# EXECUTIVE CONSULTING ENGINEERS, INC

**RE: Polaris Pointe South Filing No. 4 PUD Development Plan and Polaris Pointe South Filing No. 4 Final Plat; AR PUD 22-00062 and AR FP 22-00063**

## **PUD DEVELOPMENT PLAN**

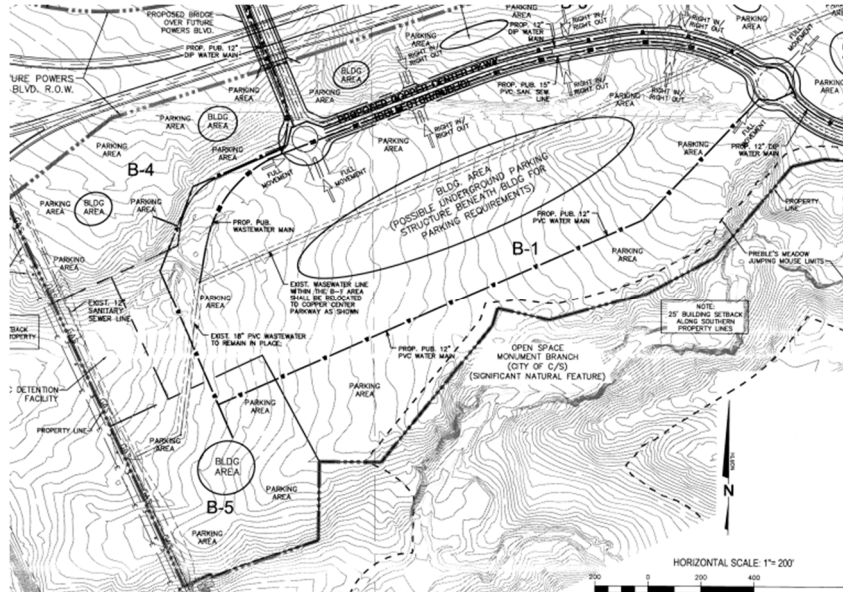
- **Remote parking is proposed at the Progressive location. This location has a right-in/right-out off Voyager at Serenity Park Drive. A Sybilla Lane, shuttles can make a left turn, without out traffic signal, however, this left turn can be particularly challenging based on the vehicle speed and visibility along Voyager Parkway. For this location, address vehicle and shuttle**

circulation out of this parking lot onto Voyager Parkway. Vehicle movement through the adjacent neighborhood is strongly discouraged. Progressive is no longer a designed remote shared parking facility. Therefore, the comment is not relevant.

- Patrons that do not want to wait for the shuttles will more than likely walk to the venue along Voyager Parkway. Connectivity of sidewalk (two missing areas) on the west side of Voyager Parkway. How will this be addressed? Missing sidewalk will be constructed by the developer prior to the first performance.
